COMMUNITY DEVELOPMENT DEPARTMENT REPORT

SUBJECT: Storyrock – AZ, MDA, PP, RZ
H-2025-0025

LOCATION: Generally located on the south side of W. Amity Rd., midway between S. Meridian Rd./SH-69 and S. Linder Rd., in the north 1/2 of Section 36, T.3N., R.1W

STORYROCK SUBDIVISION
 MERIDIAN, ID
 PRELIMINARY PLAT LANDSCAPE PLAN

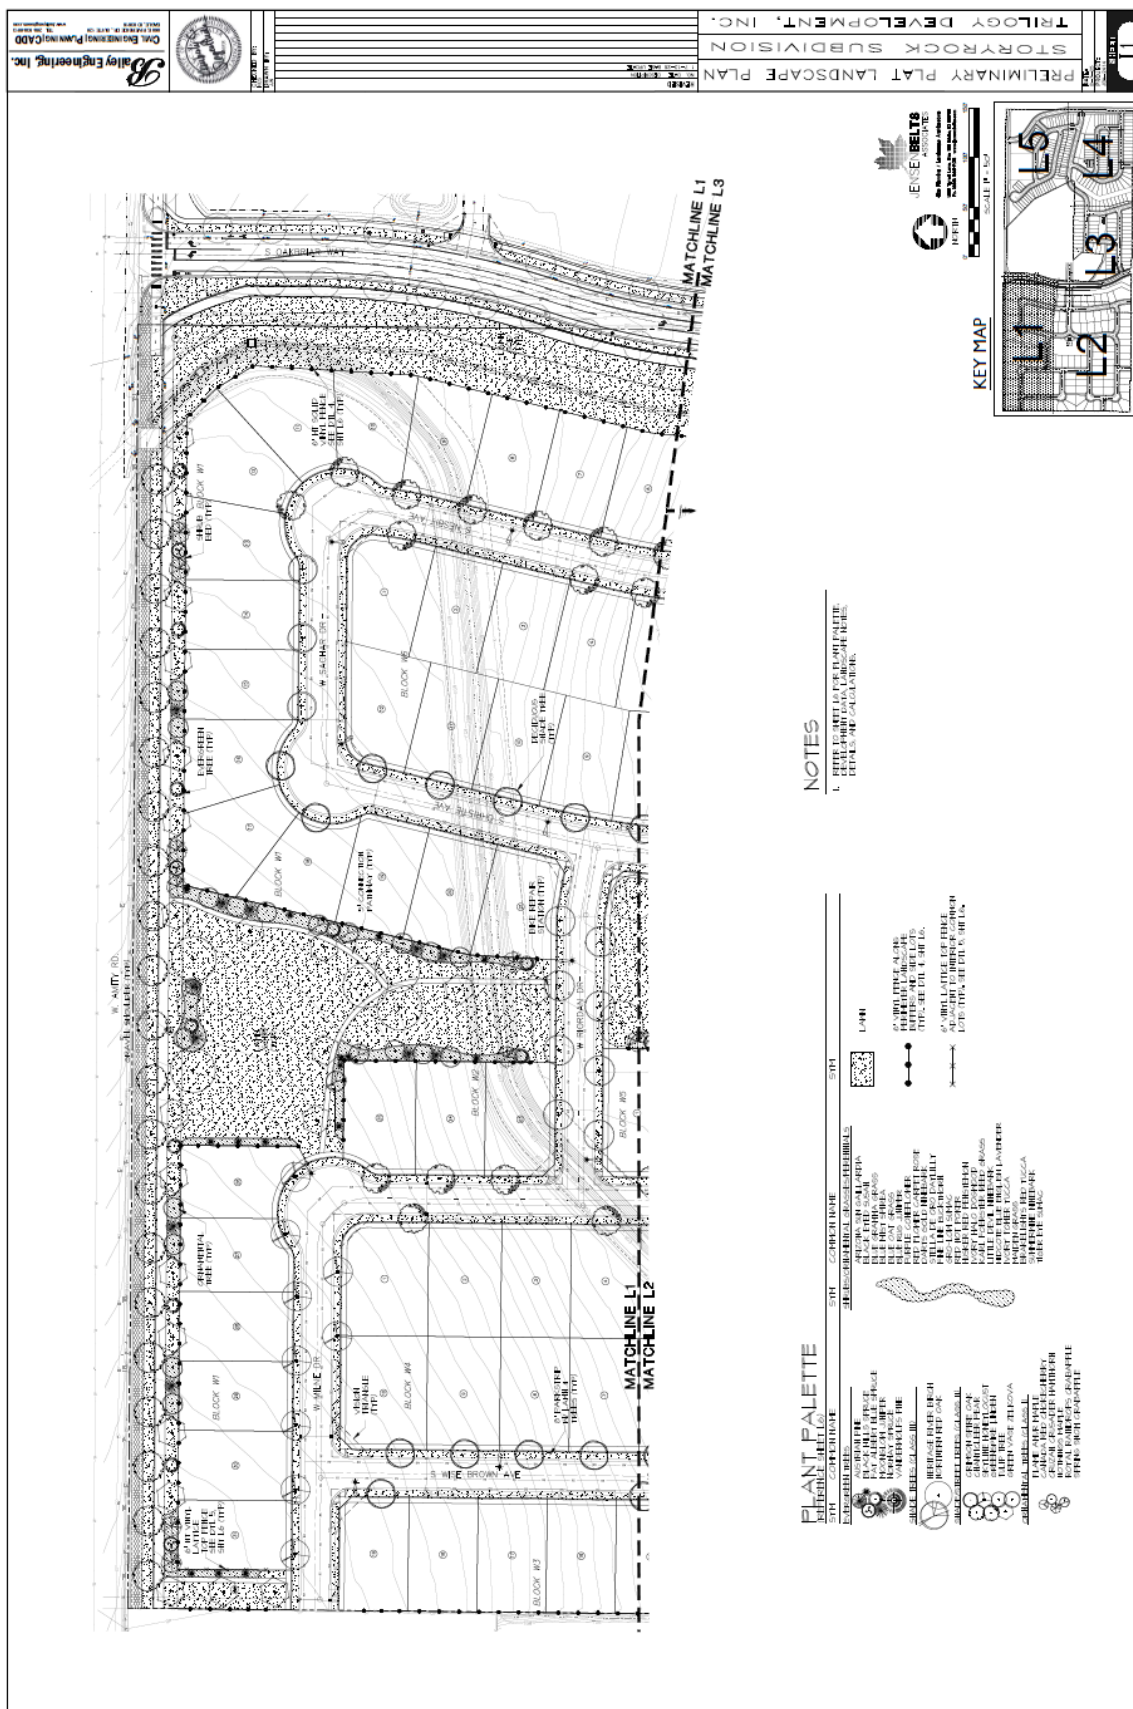
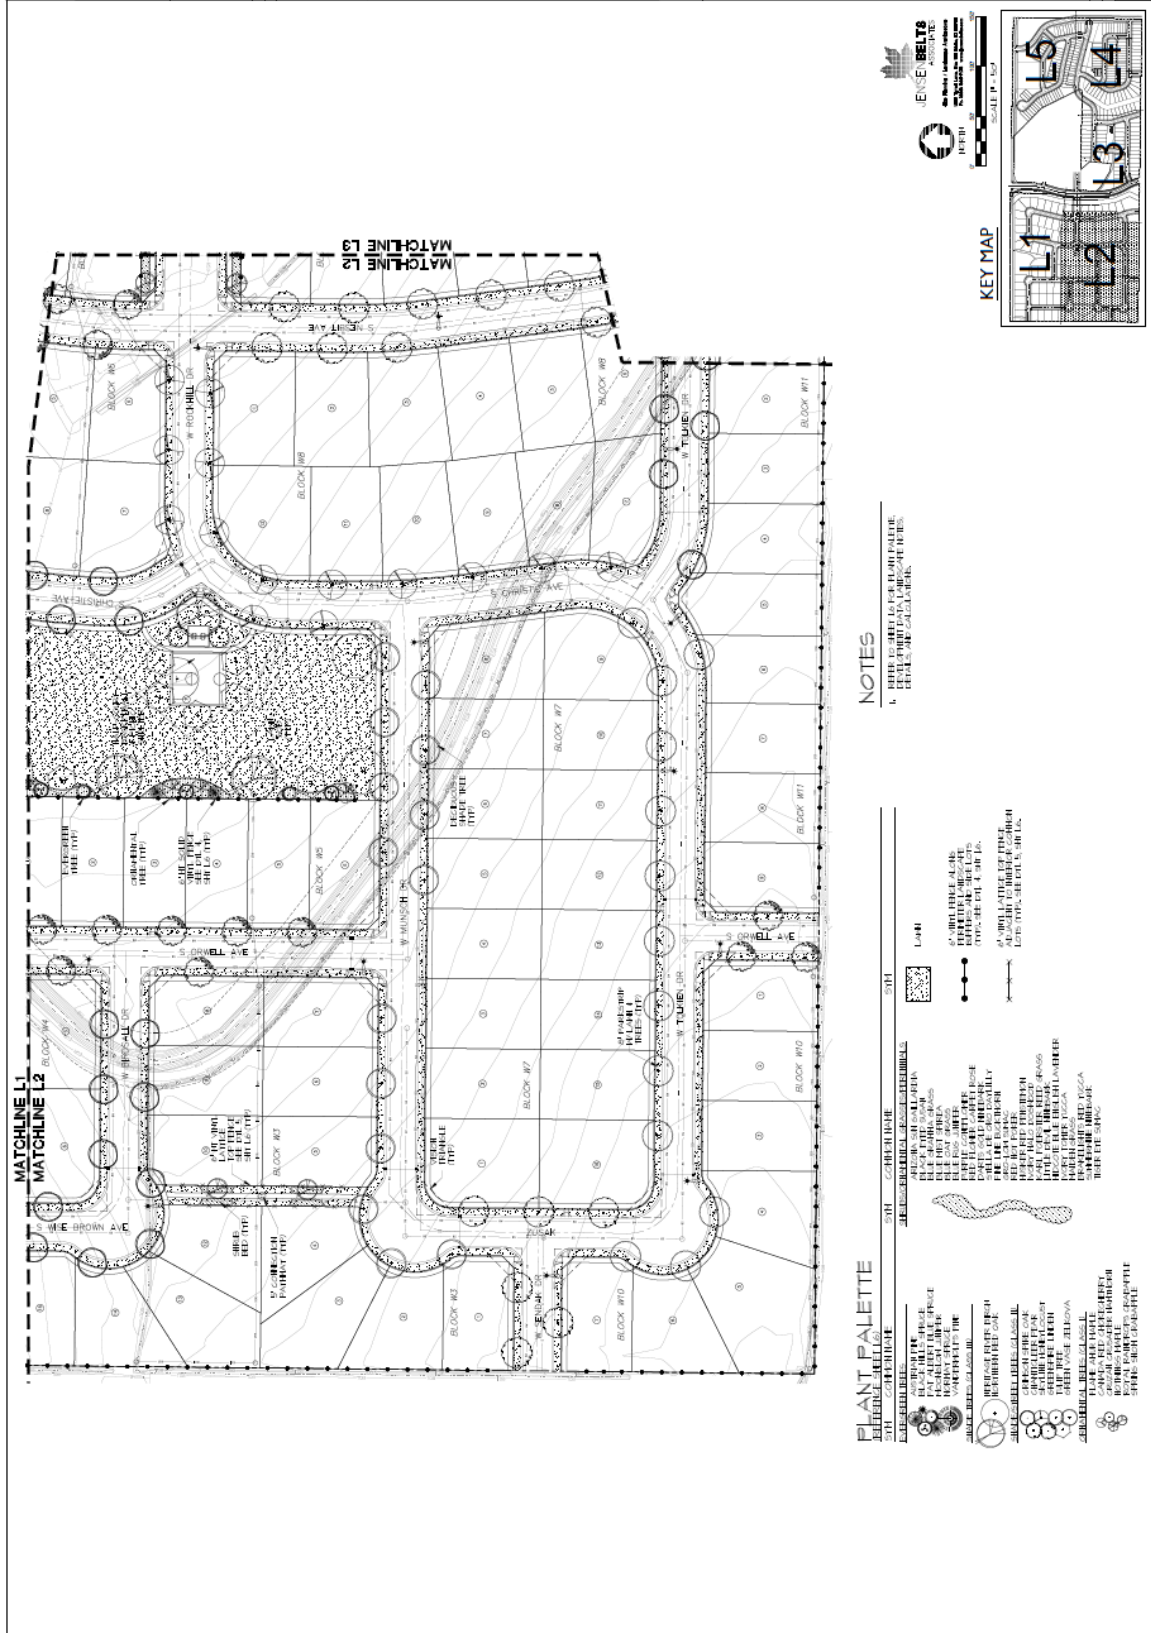
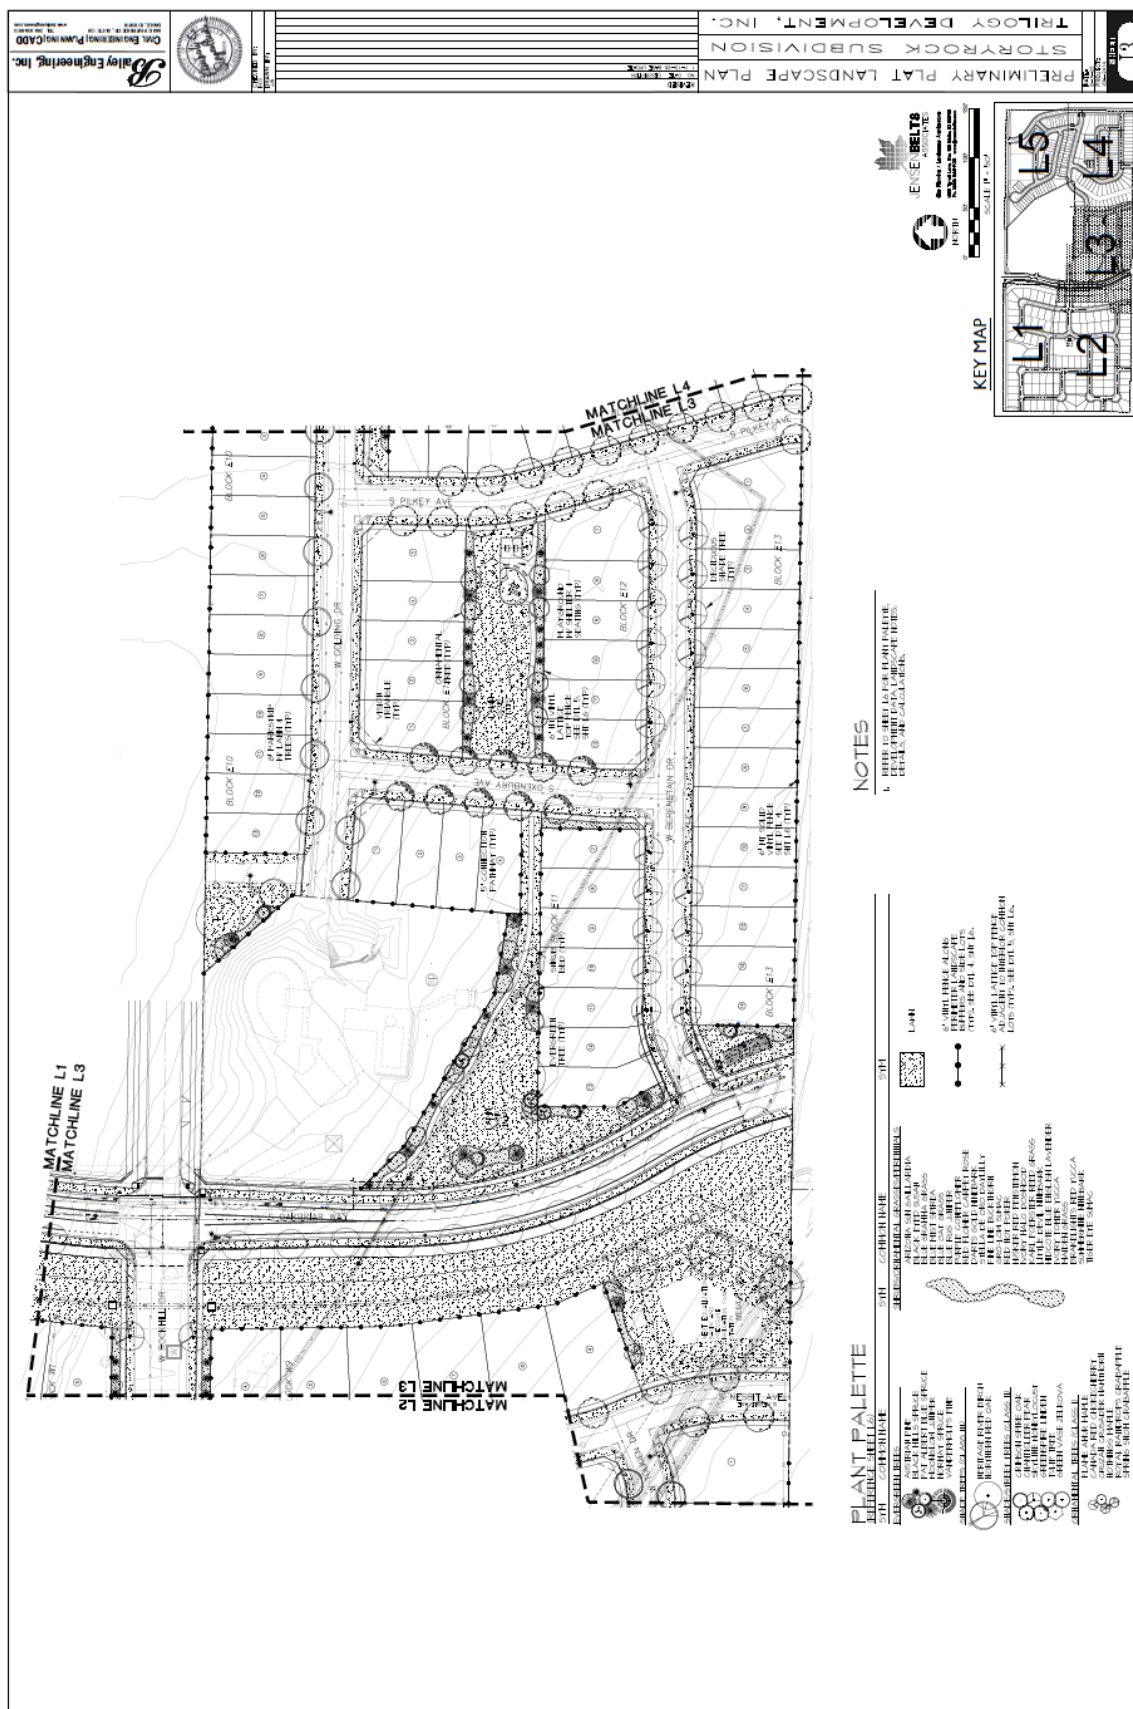
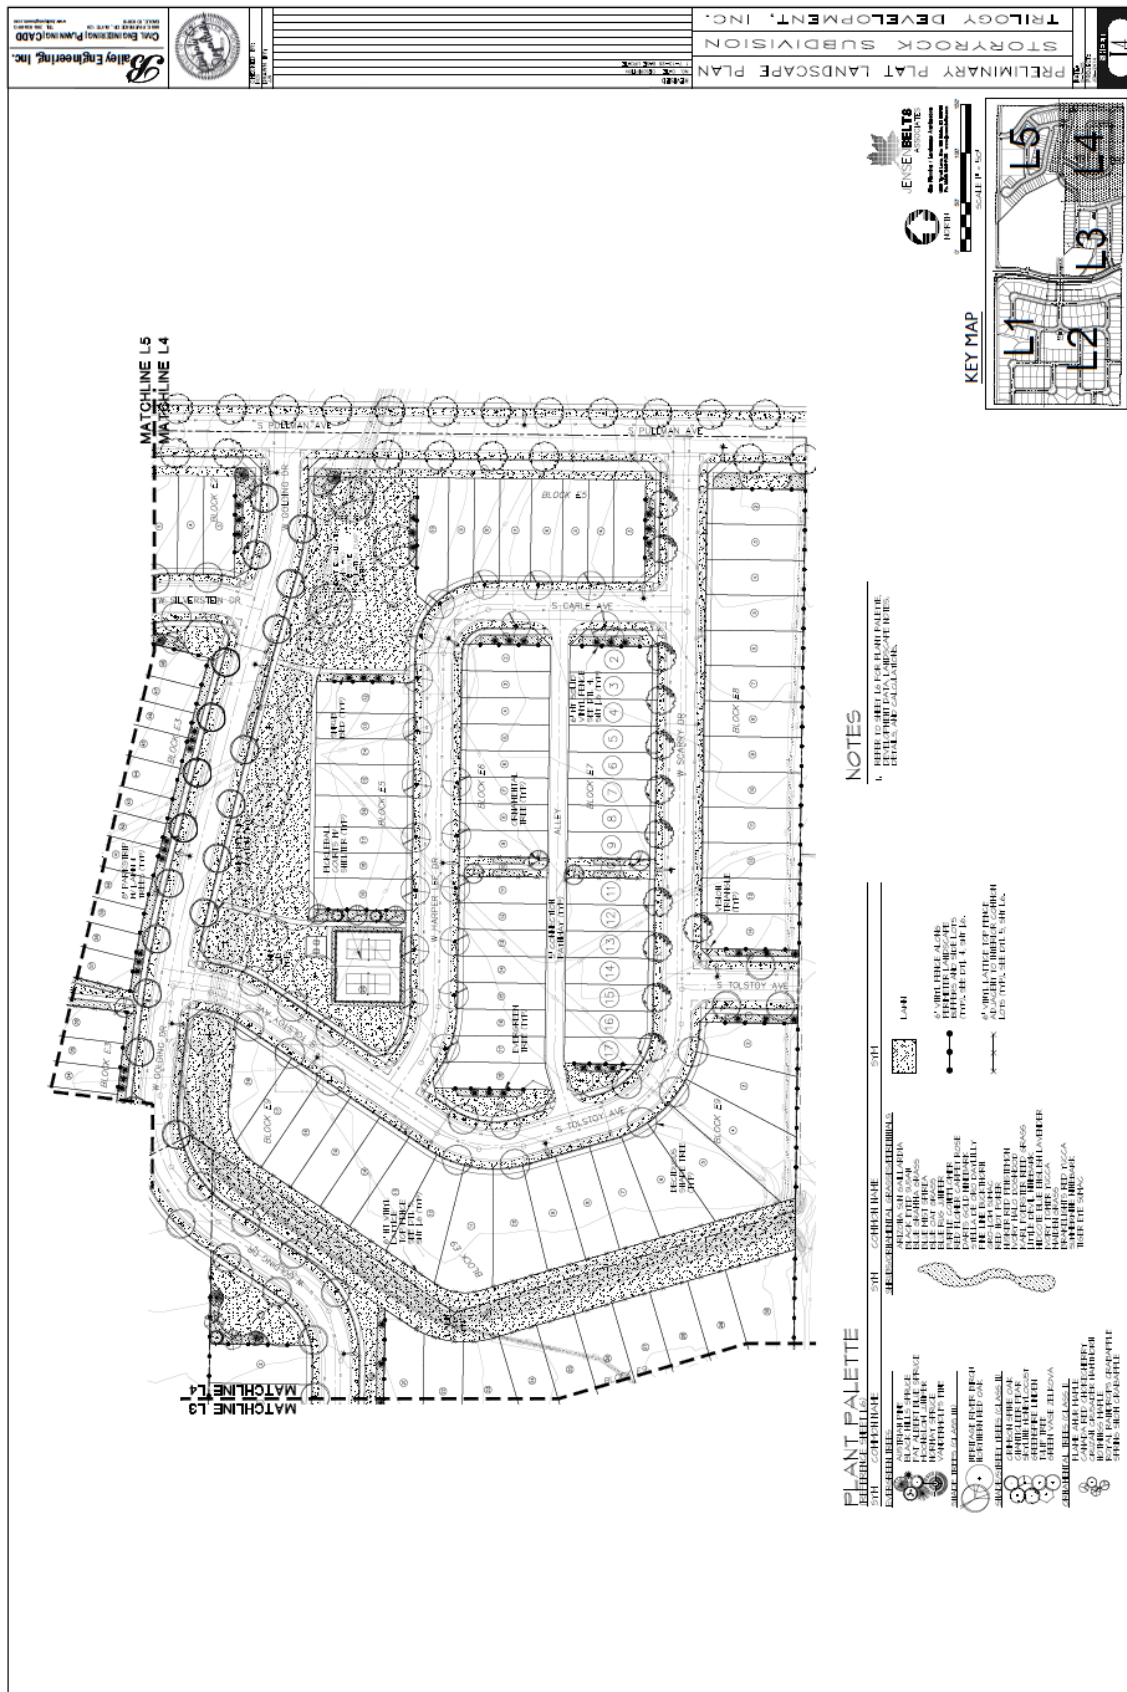
The street buffers along W. Amity Rd. (arterial) and S. Oakbriar Way (collector) are required to comply with the enhanced buffer requirements in UDC 11-3G-3B.3 and 11-3B-7C.3f in order to count toward the qualified open space requirement. Details should be included on a revised landscape plan explaining what enhanced buffer elements are proposed.

The Landscape Calculations table on the landscape plan should include the following: length and width of the street buffer and tree classifications for S. Oakbriar Way, Pullman Ave. (if designated as a collector street) and road through Lot 10, Block E3; length and width of parkways (aka residential subdivision trees) and the required vs. provided number of street trees and tree classification.

At a minimum, common open space areas should include one (1) deciduous shade tree for every 5,000 square feet of area and include a variety of trees, shrubs, lawn or other vegetative groundcover. **The square footage of common areas and the required number of trees should be included in the Landscape Calculations table on the landscape plan.**

The landscape strips are required to be planted with a mix of trees, shrubs, lawn, and/or other vegetative groundcover. A minimum of one (1) tree per 100 linear feet of pathway is required. **The length of pathways and required vs. proposed number of trees that demonstrate compliance with the standards in UDC 11-3B-12C should be included in the Landscape Calculations table.**
